STANDARD SPECIFICATIONS, SPECIAL PROVISIONS, AND STANDARD DRAWINGS

RECURRING PLAN DETAILS (proposed new)

PROPOSAL TO STANDARDS COMMITTEE

LEAN CONCRETE BASE SUBSTITUTION FOR 9" SUBBASE FOR PCCP DETAILS

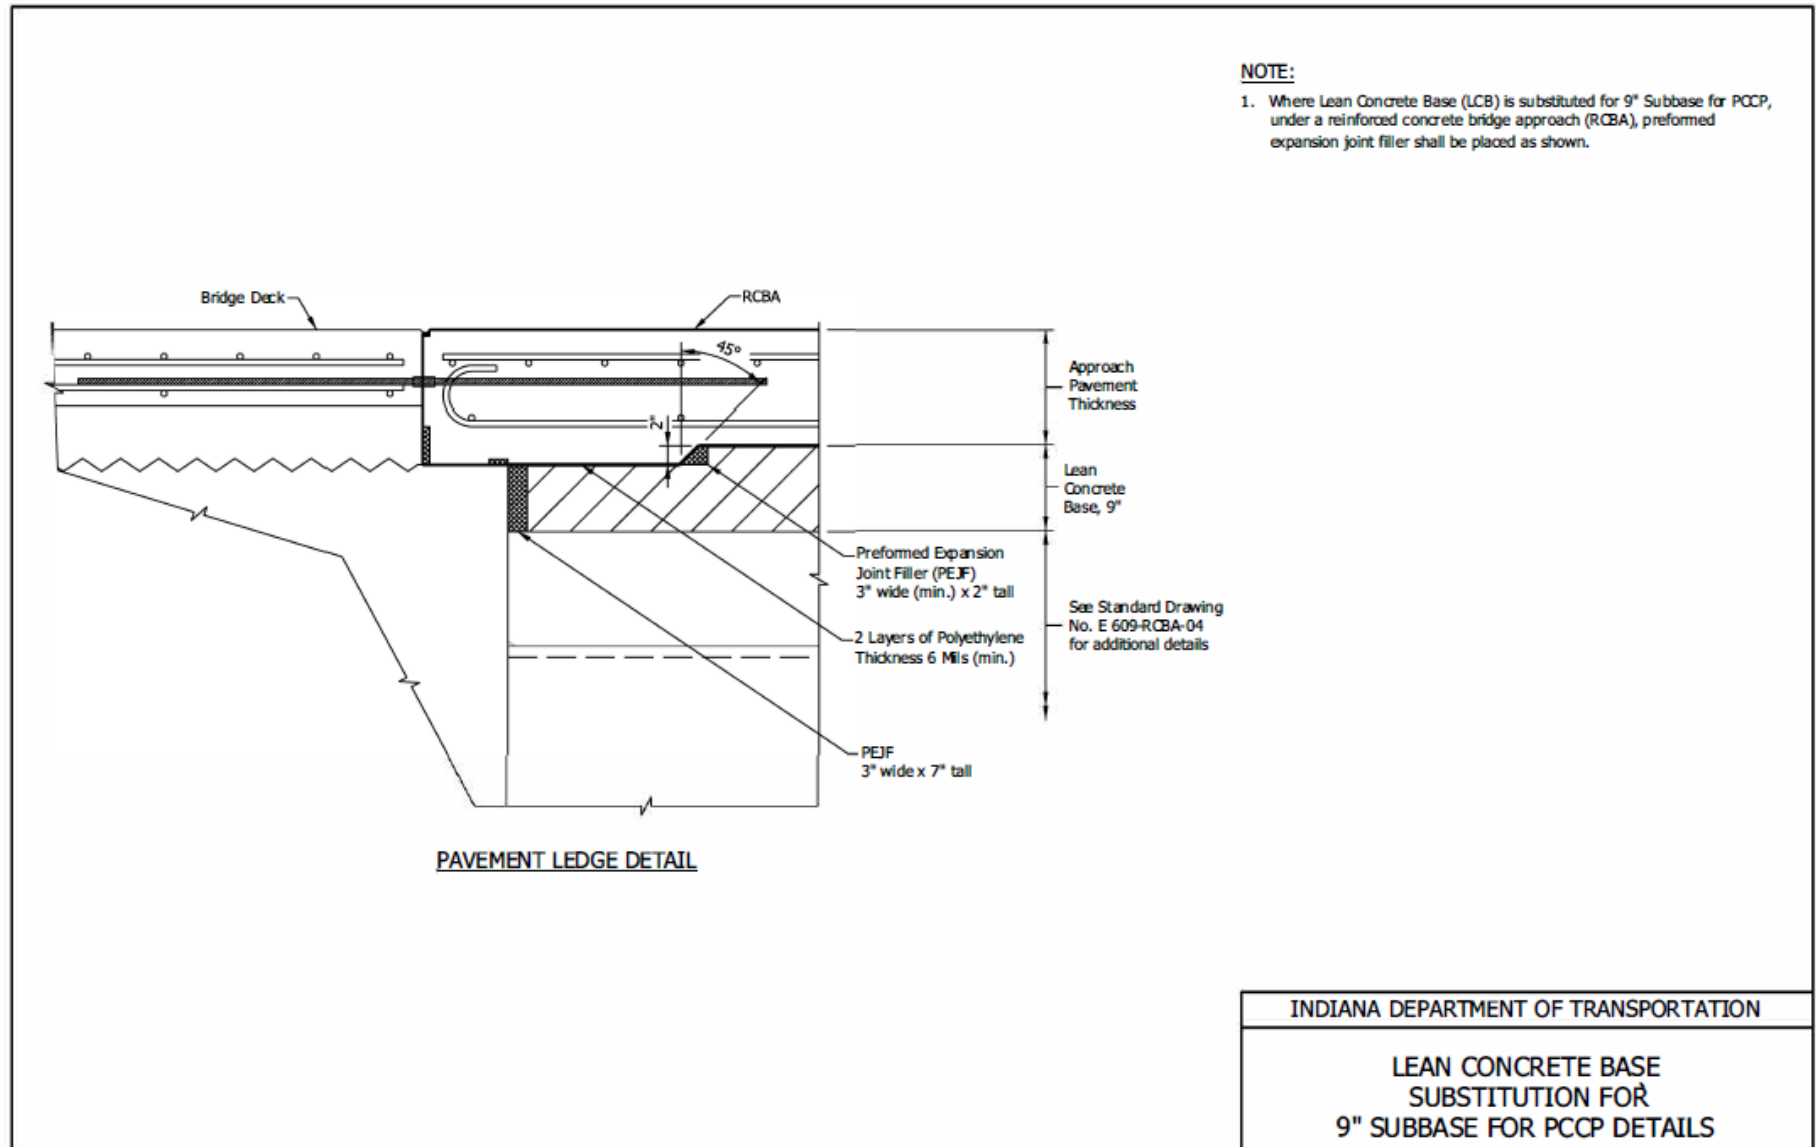
PROBLEM(S) ENCOUNTERED: Per RSP 309-R-793, Lean Concrete Base, preformed expansion joint filler is required in two locations when LCB is used in conjunction with a reinforced concrete bridge approach (RCBA) – the vertical interface between the end bent and the LCB and at the sloped edge of the LCB adjacent the thickened portion of the RCBA. Some installations have overlooked these structural requirements.

The PEJF is required with semi-integral and integral end bents, but it is acceptable to use it at any end bent.

PROPOSED SOLUTION: Create a recurring plan detail showing the required PEJF locations to support the specification requirements.
